## Dodder Greenway Emerging Preferred Route Consultation - October 2018

### 1.0 Introduction

## SECTION 1-1 THORNCASTLE STREET (COMMUNITY CENTRE)

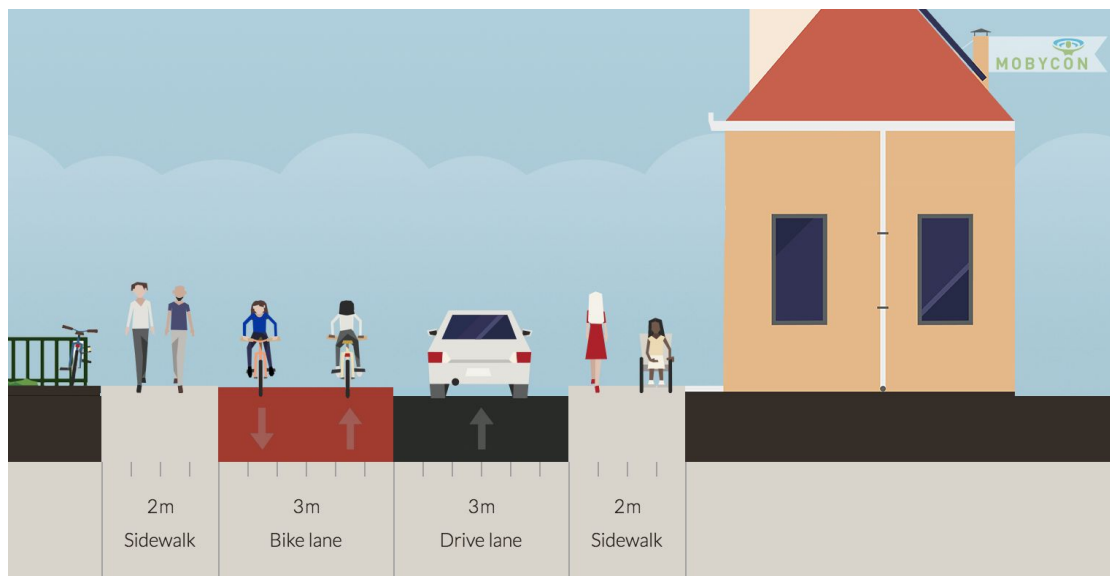
The current proposals on Thorncastle Street as part of the preferred route are of poor-quality for pedestrians and cyclists. Below is cross-section 1-1, which is for a short section of along Thorncastle street.

The three metre wide shared space for pedestrians and cyclists is unacceptable within a busy urban context and drops the quality-of-service far below A. Reallocating the space currently given to on-street car parking spaces to the greenway resolves this issue. There is ample on-street car parking in the area. A possible cross-section:

### 3.3 Thorncastle Street; Cross-section 2, Zone 2

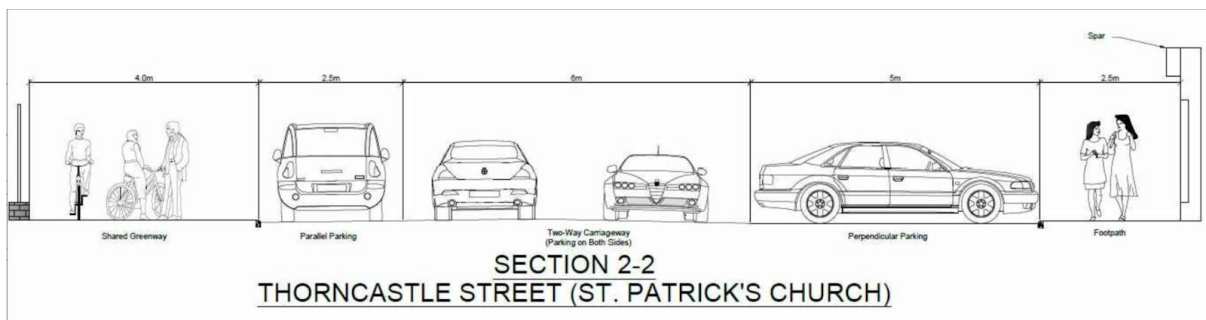
At cross-section 2 another poor quality option is proposed while maintaining a huge amount of space for motor traffic. The NTA and the City Council need to reallocate road space to pedestrians and cyclists if they want to see modal-shift towards these sustainable modes. Emerging preferred route cross-section 2 below:

In this 20 metre cross section there is only 6.5 metres for sustainable transport. Potential solutions include removing the parallel on-street car parking. Or even changing the perpendicular parking to angled and reducing the width of the parallel parking from 2.5m to 2.1m, providing a buffer space between the parked cars and the cycle track as required by National Cycle Manual. Either option would provide enough space to create a 5 metre wide segregated greenway corridor for pedestrians and cyclists.

### 3.5 Zone 4

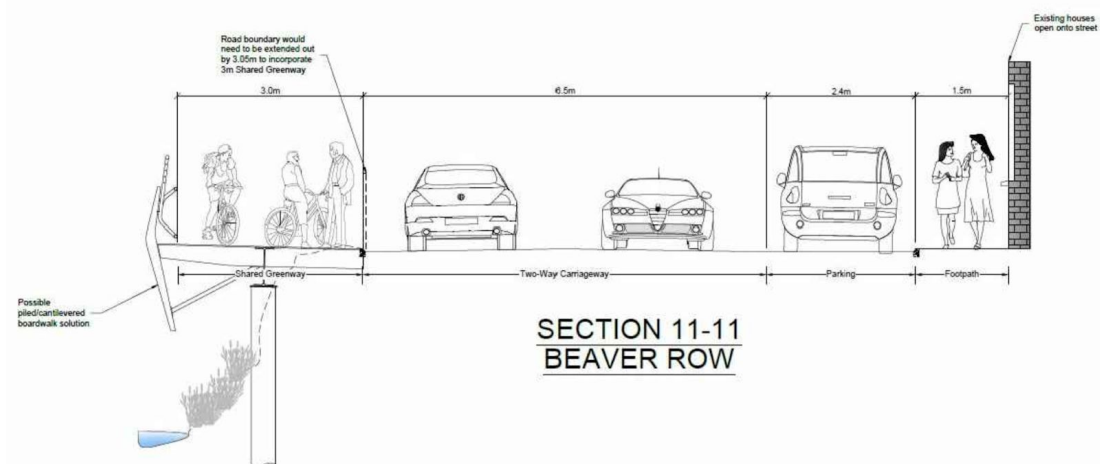
We welcome both the widening of the path to 5m and the widening of the underpass of the Irish Rail line. Given the 5m width the path should be segregated into 2 metres for pedestrians and 3 metres for cyclists (see section 2.3 above).

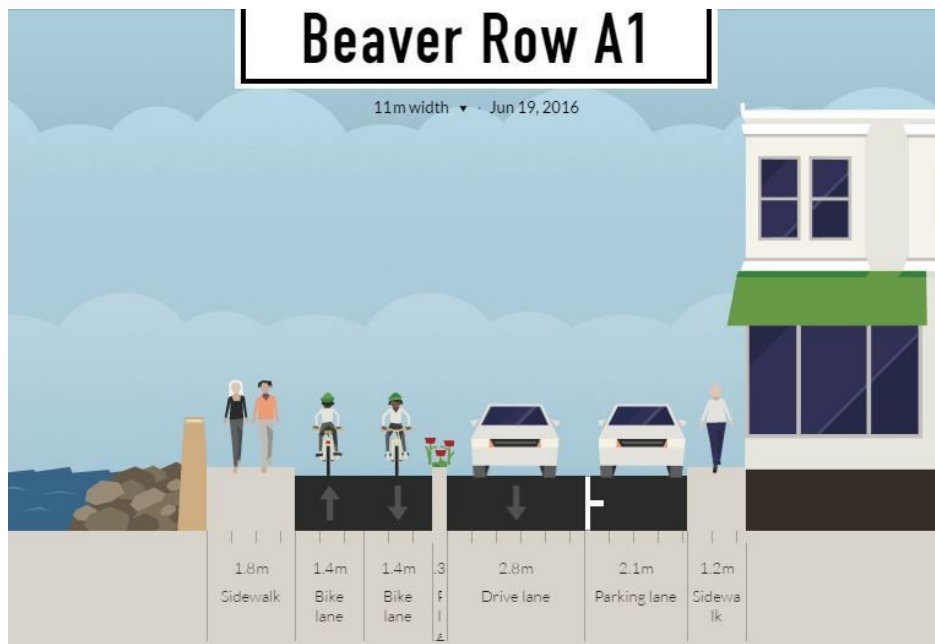
Above is cross-section 11 from the alternative route along Beaver Row. There is no on-street car parking along this section of road currently. Not adding on-street car parking and reducing the two-way carriageway to 6 metres (inline with DMURS) means there is no need to install an expensive and environmentally destructive piled or cantilevered path along this stretch of the river bank.

If the council wishes to formalise the current illegal on-street/on-footpath car parking we recommend that Beaver Row be made one-way from Donnybrook Court to Beach Hill Avenue. This would provide the necessary space for the Dodder greenway and on-street parking for residents along this stretch without destroying the natural environment along the Dodder. A possible cross-section below, which involves no environmental impact and works within the existing road space:
